After reading the both the Applicants' Responses to the Written Representations, and the Examiner's Second written questions, I wish to make the following points.

7.5 Habitat Constraints Plan

The image below is taken from Figure 1f: Illustrative Landscape Strategy Plan. On-site access tracks are shown in white and the Twin Oaks Tree is the dark green circle in the centre. Reference is made to the 2m space for a new hedgerow.

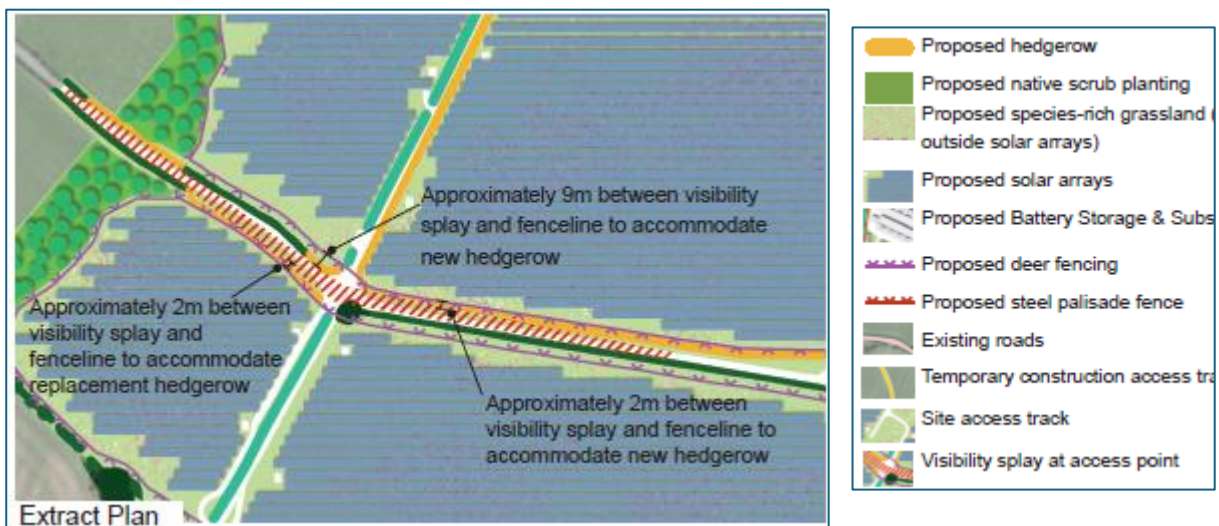
In my written representation, I identified the risk that the construction compound south of Coton Road would potentially impact the well-known landmark of the Twin Oak (T105). The Applicant's response is that protection will be provided in accordance with relevant guidance. Based on BS5837 the tree protection zone will be 15 x stem diameter (approximately 15m diameter) and yet the proposed construction route to the compound will pass less than 5m from the tree.

The Applicant plans a hedge protection zone of 5m for existing hedges. But for new hedges it specifies an offset from the security fencing by 2m. How does the Applicant propose to maintain these hedges if they are this close to the security fence as there is insufficient room for a tractor to drive in between the gap.

The Images below show how the Coton Road access development will impact the local landmark, Twin Oaks tree on this highly visible plot of land.

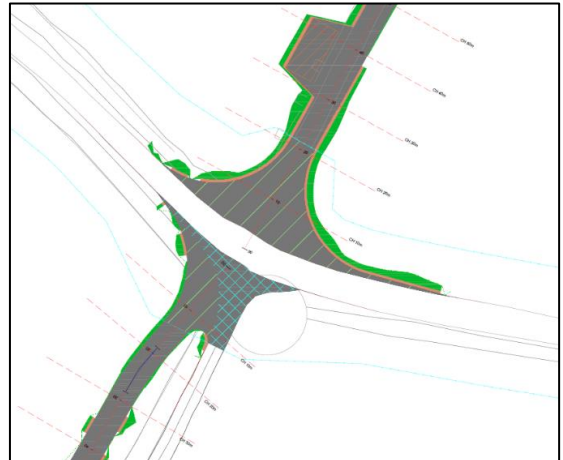
The following image is from page 17 of the 6.14 Arboricultural Survey Report showing the root protection zone for the Twin Oak tree that will be clearly impacted by the access routes. The other image (from Appendix 4.7) shows the road widening at Coton Road, with a tarmac entrance (blue cross hatching) on the root protection zone for the Twin Oak tree.

The following Works Plan (Appendix 1.3, Sheet 4) shows the proposed construction compound at the Twin Oak tree, once again in the root protection zone.

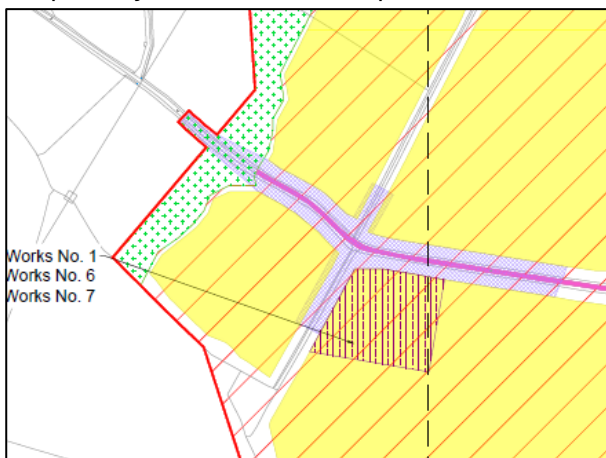
This is a highly visible area to all users of Coton Road, and will cause noise, light and air pollution to local residents. I see no reason why works in the fields south of Coton Road cannot be serviced by the primary construction compound in the centre of the site.

See below for an extract of a typical graph provided in the Glint and Glare assessment (I have added the blue text boxes as commentary).

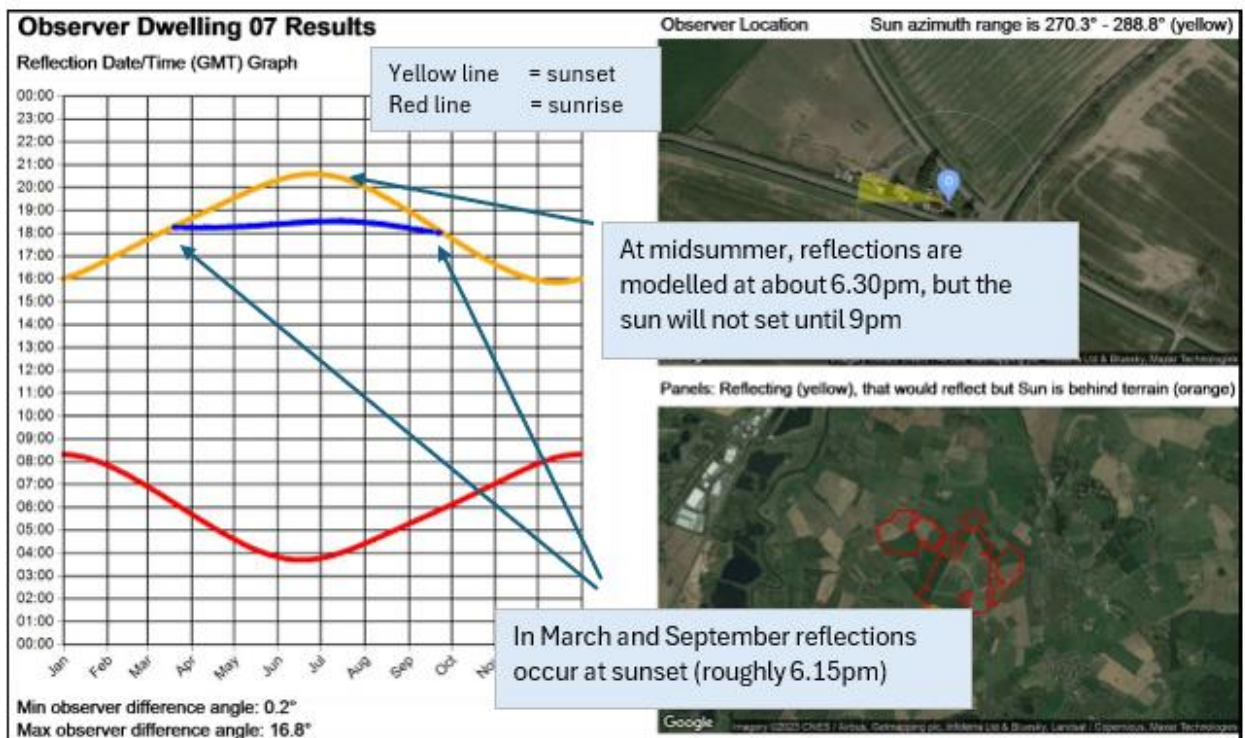
I do not fully understand the explanation from Pager Power as to why glint and glare effects do not occur at different times of the day for the solstice and equinoxes. They state:

If the maximum chance of reflection occurs “when the sun is low in the sky”, at sunrise and sunset, then presumably the timing should change throughout the year. I note that the Applicant states that 30° tilted panels show less seasonality however, I would like to understand how this works in practice.

I would welcome further explanation as to why predicted reflections occur at roughly the same time of day, and for the same duration each day, even though sunrise and sunset varies throughout the year.
